**FINAL DRAINAGE REPORT  
FOR  
PLATTE SELF STORAGE  
COLORADO SPRINGS, COLORADO**

**AUGUST 2024**

TNE Job No. 2419.00  
County Job No. PPR2418

**Figure 8-12. Inlet Capacity Chart Sump Conditions, Curb Opening (D-10-R) Inlet**

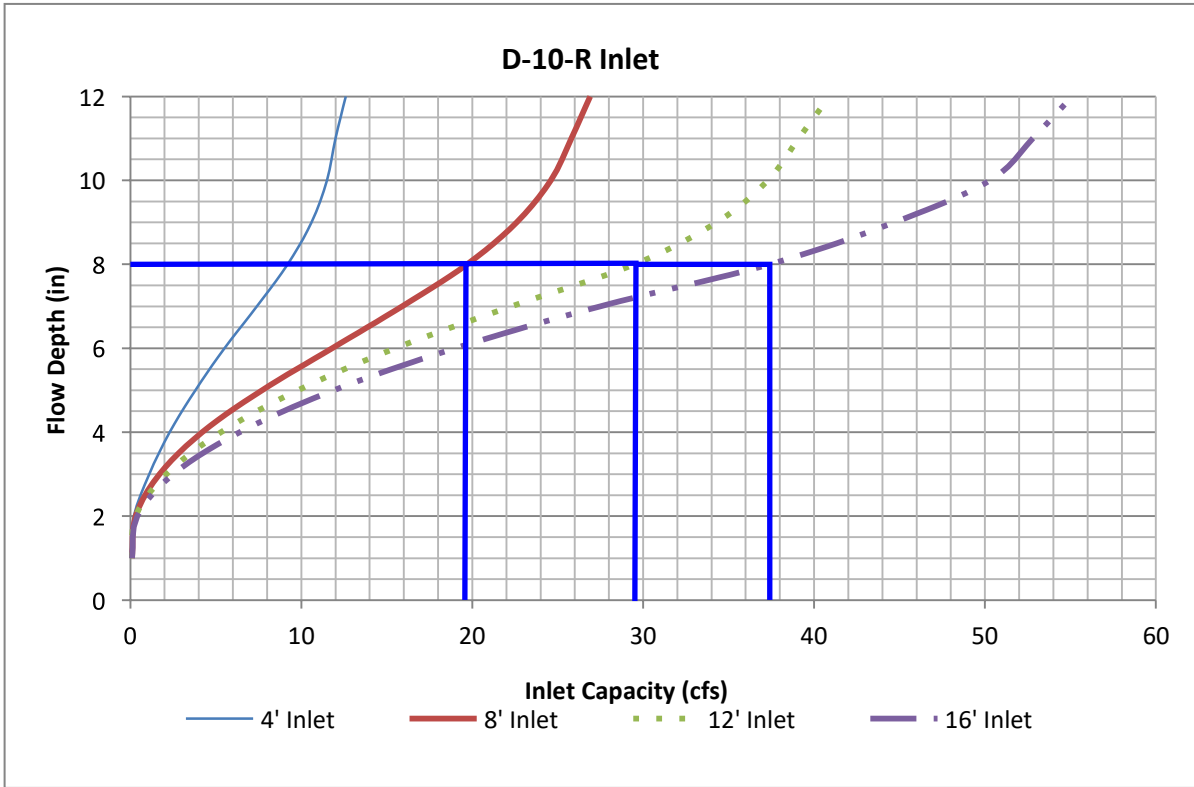
D-10-R inlets are used in the city. County uses CDOT Type R inlets. Please revise

**Figure 8-10. Inlet Capacity Chart Sump Conditions, Area (Type C) Inlet**

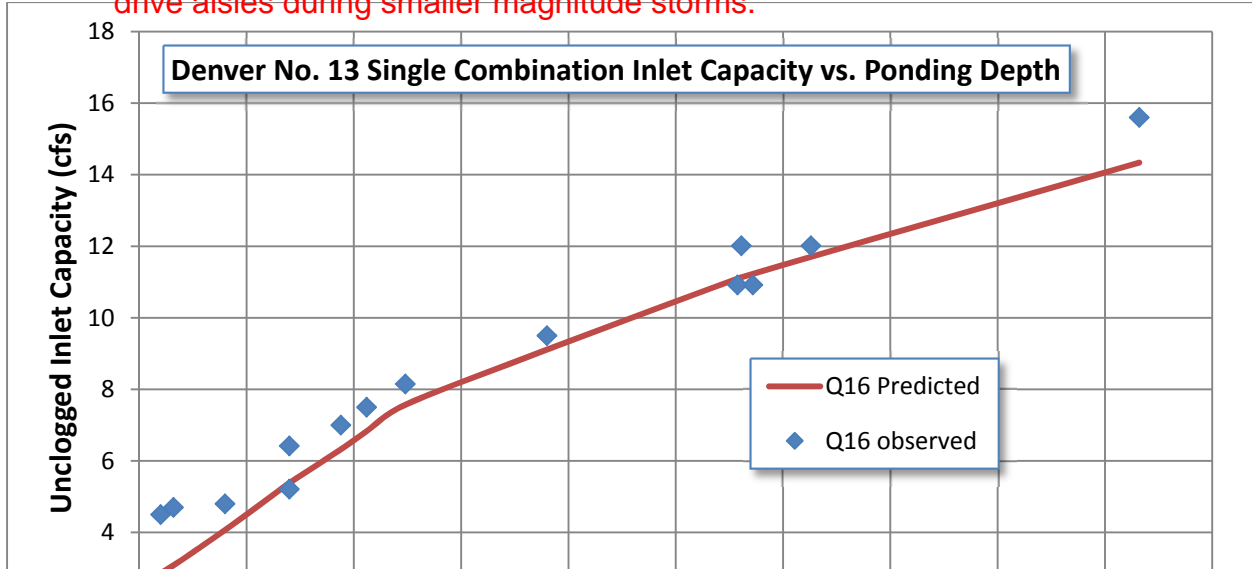
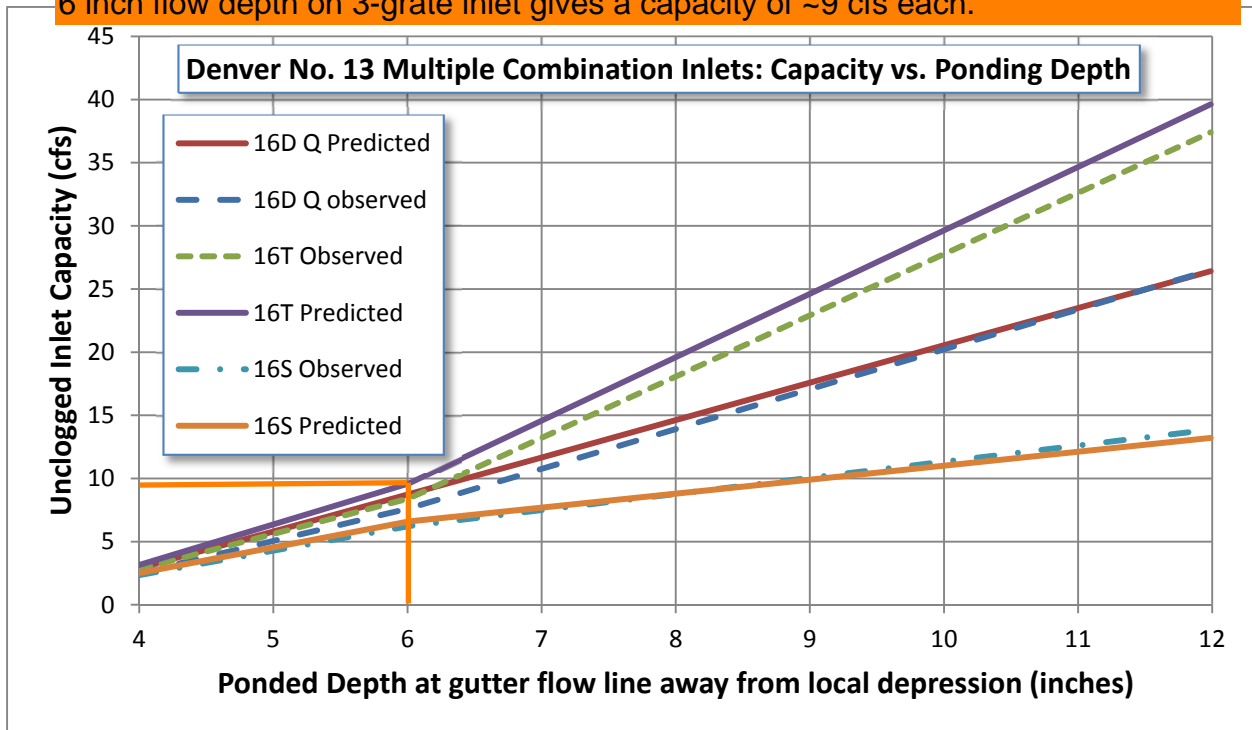
**Note to County Reviewer:** The type 13 area inlets on this project have zero flow requirements (even with 100% bypass on them the storm system still functions properly). They are being used for junctions and to reduce the amount of runoff in the drive aisles during smaller magnitude storms.

# Pond Outlet

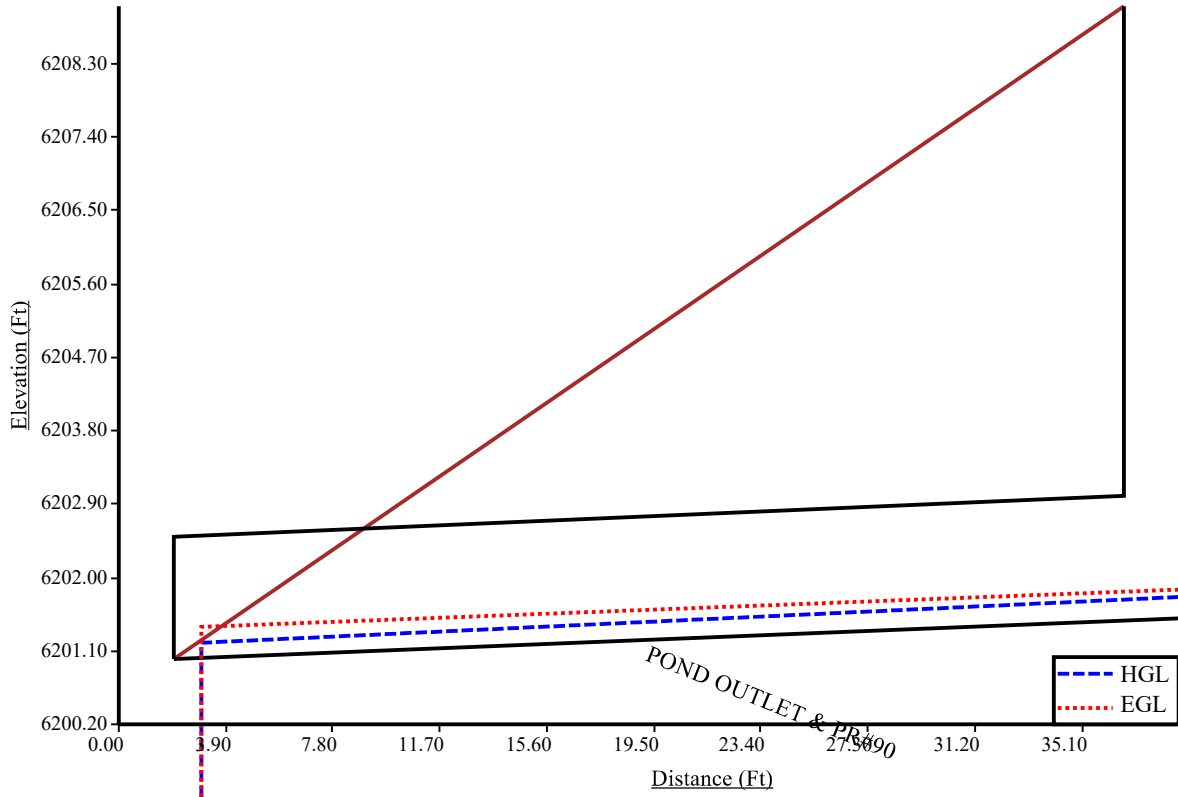
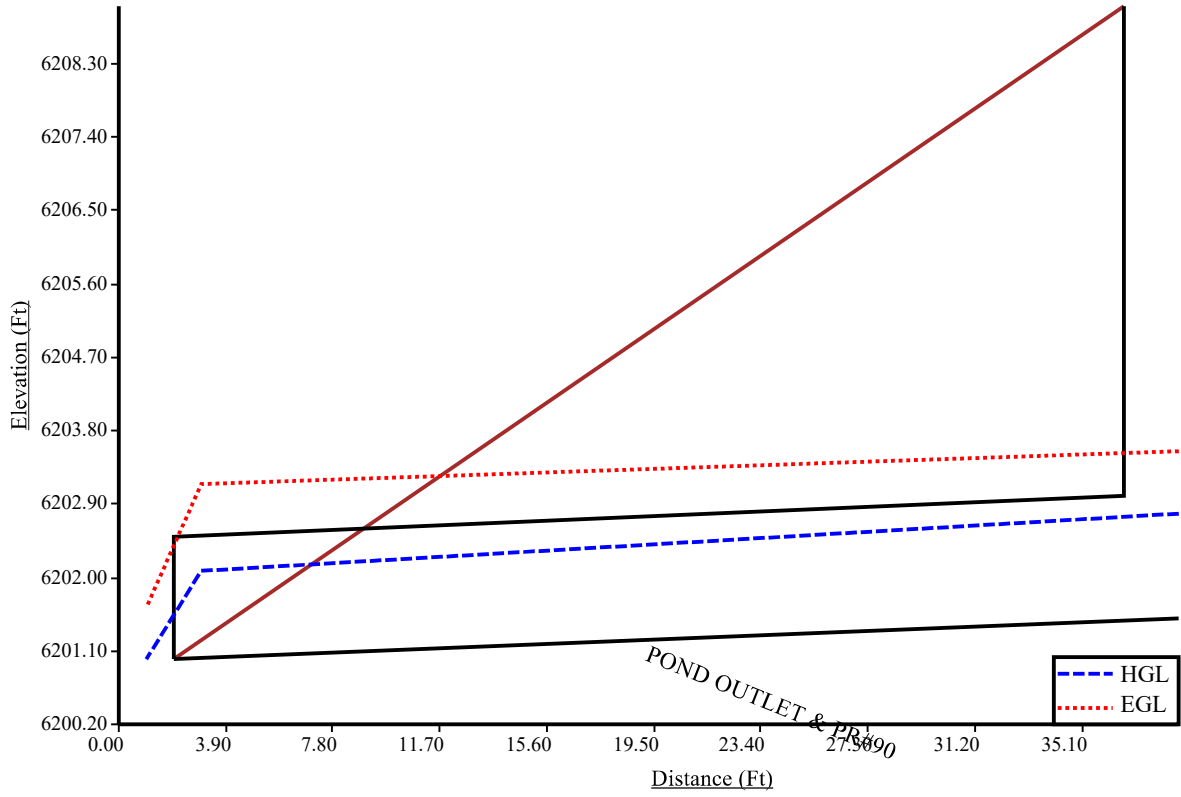
Why do these lines drop off? Verify input information

## **DETENTION CALCULATIONS**

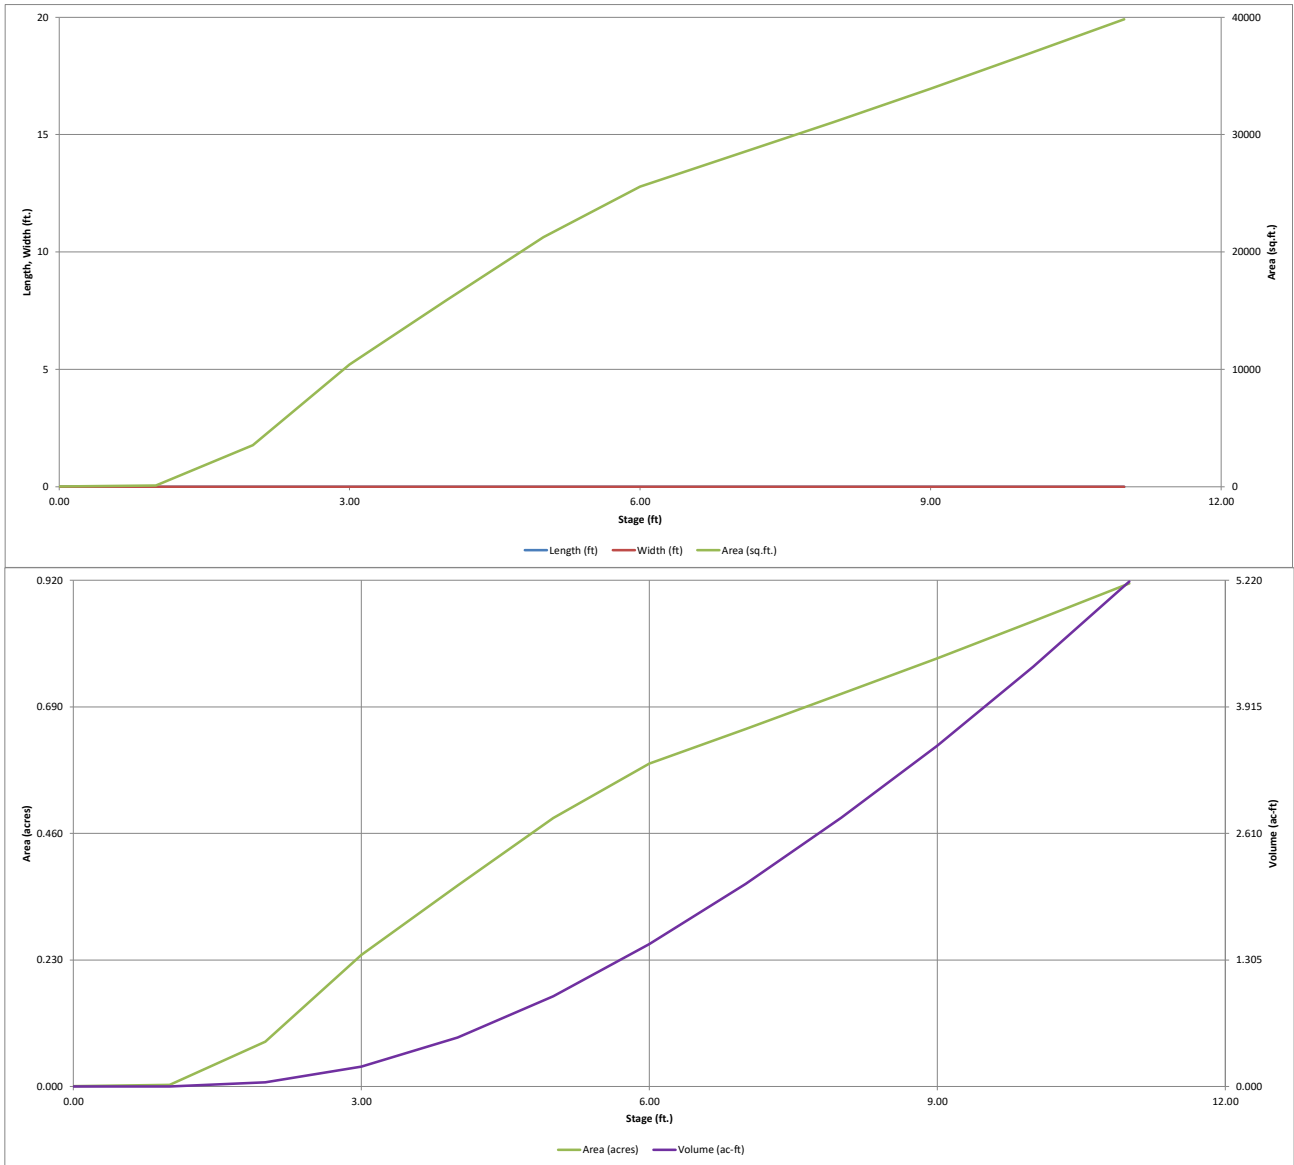
Provide spillway riprap sizing calcs

# PROPOSED DRAINAGE MAP

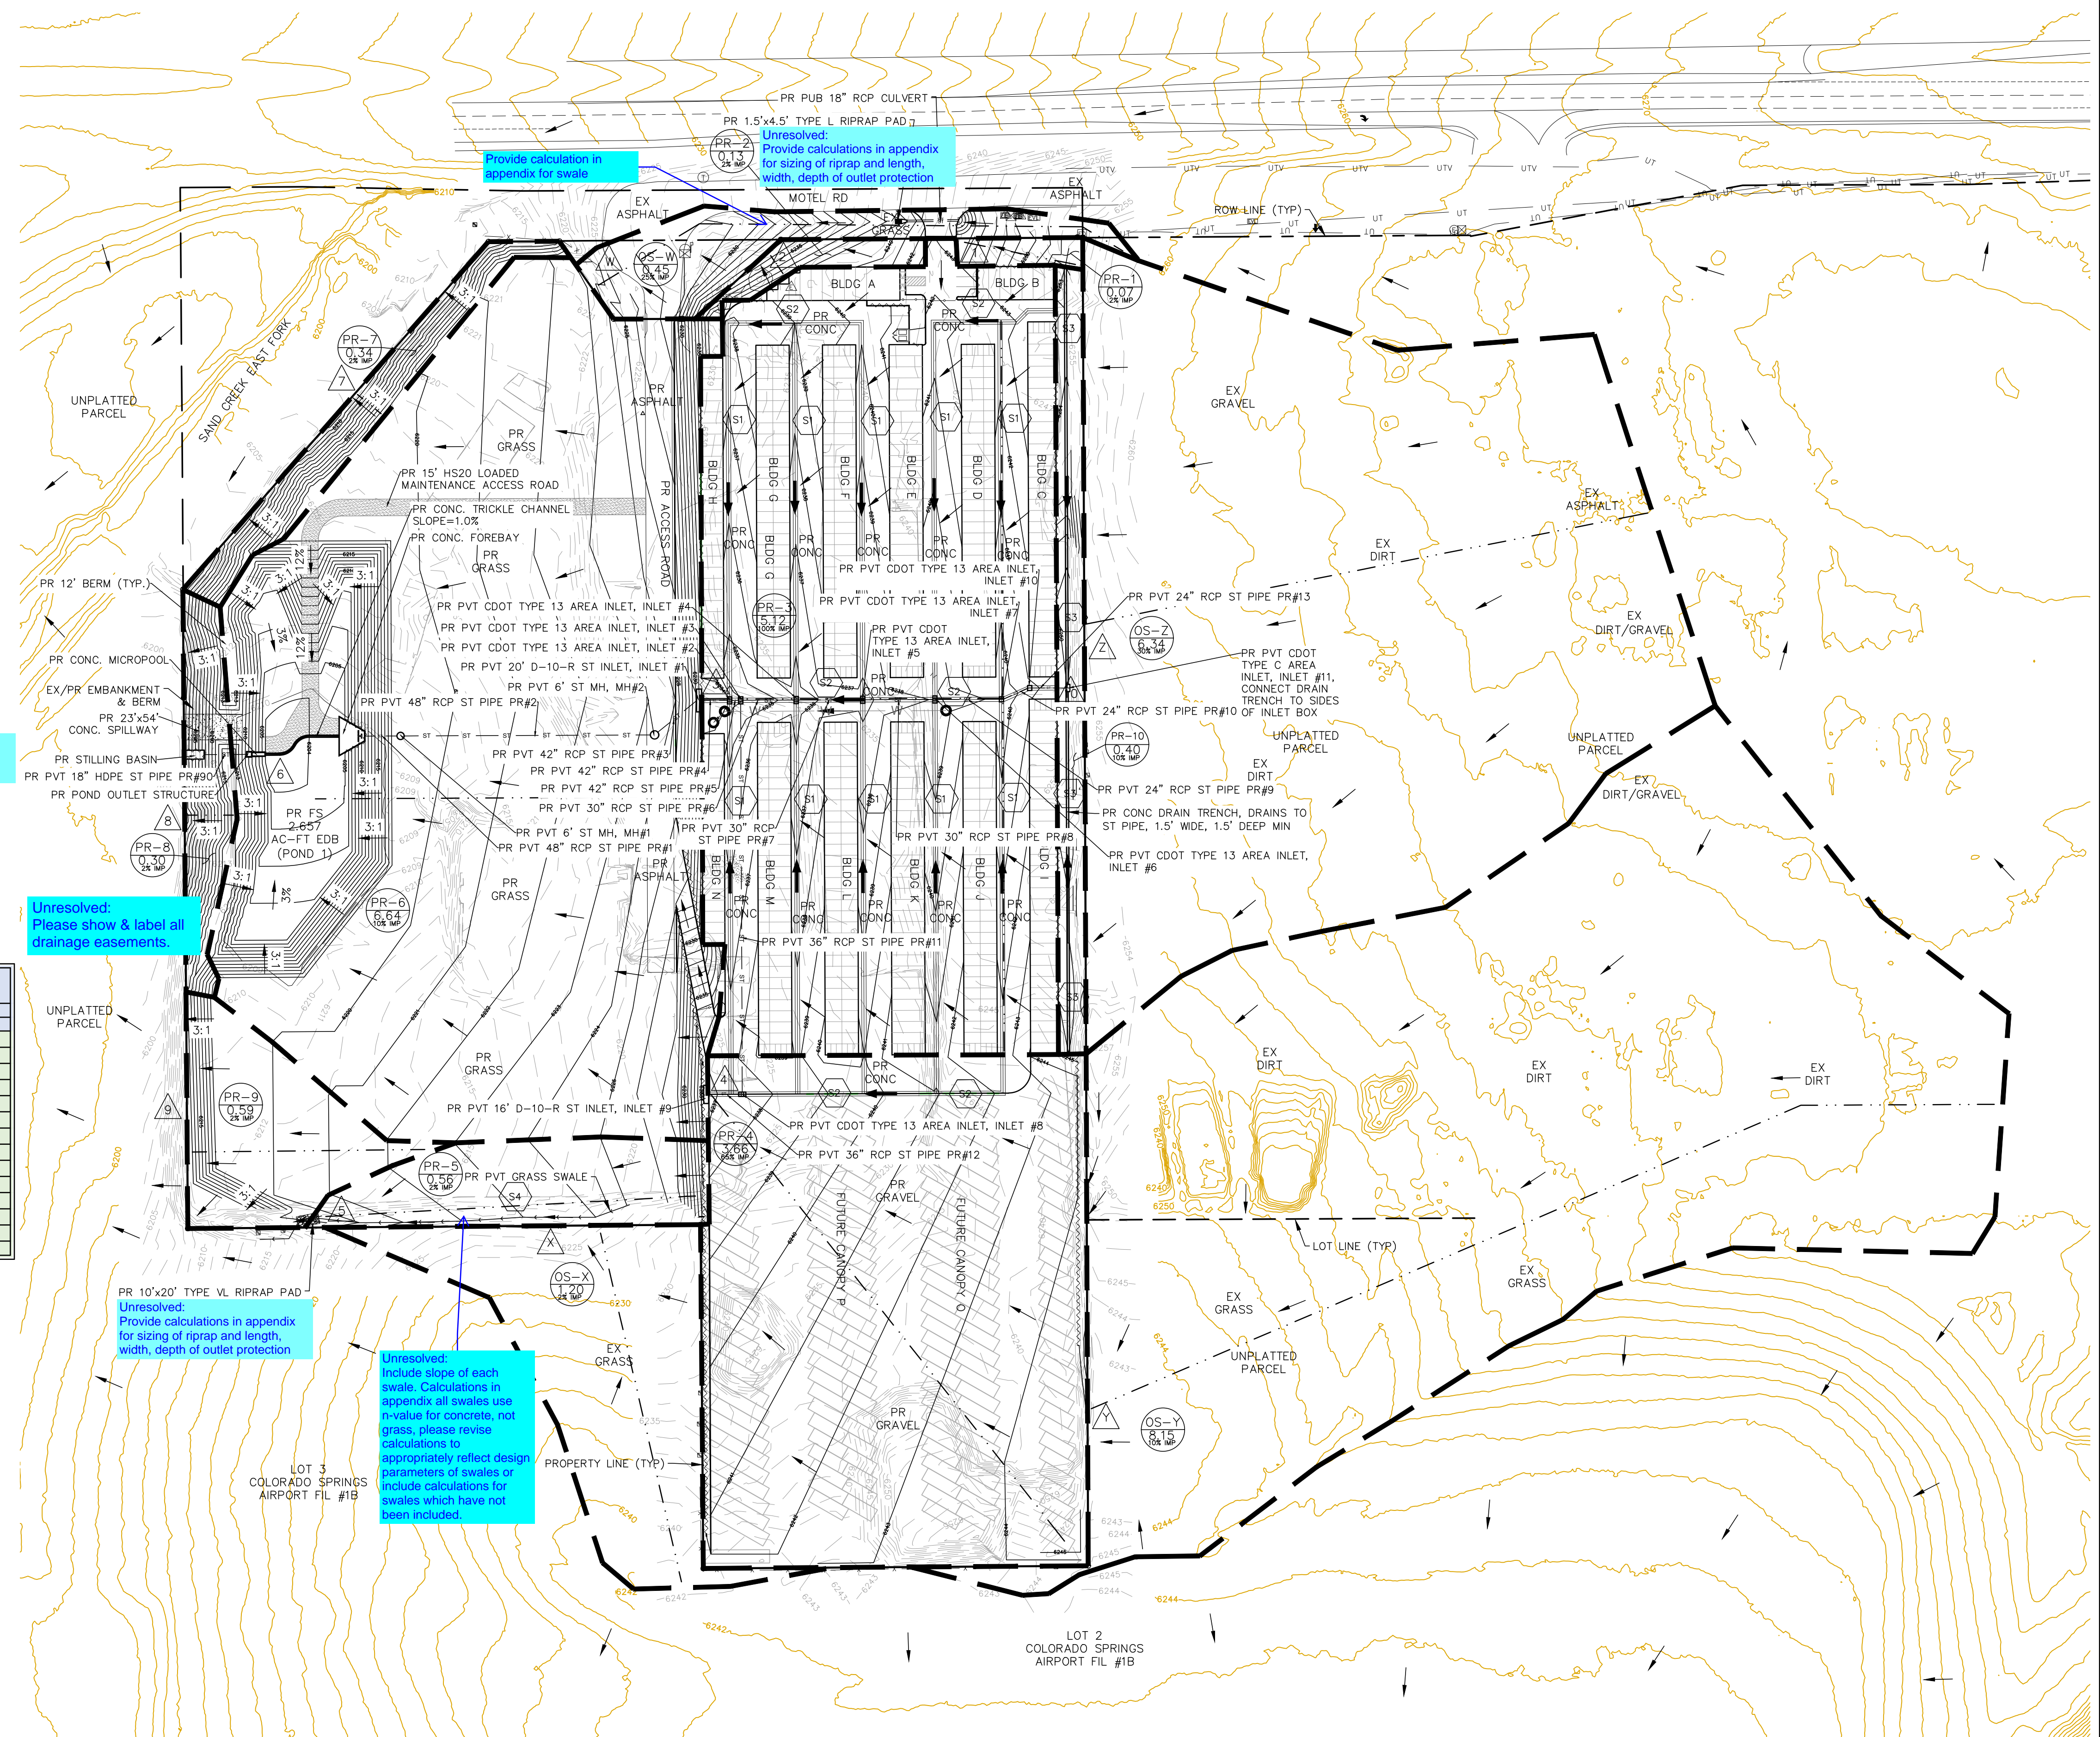
Unresolved:  
Provide calculations in appendix for sizing of stilling basin

Unresolved:  
Please show & label all drainage easements.

Unresolved:  
Provide calculation in appendix for swale

Unresolved:  
Provide calculations in appendix for sizing of riprap and length, width, depth of outlet protection

Unresolved:  
Include slope of each swale. Calculations in appendix all swales use n-value for concrete, not grass, please revise calculations to appropriately reflect design parameters of swales or include calculations for swales which have not been included.
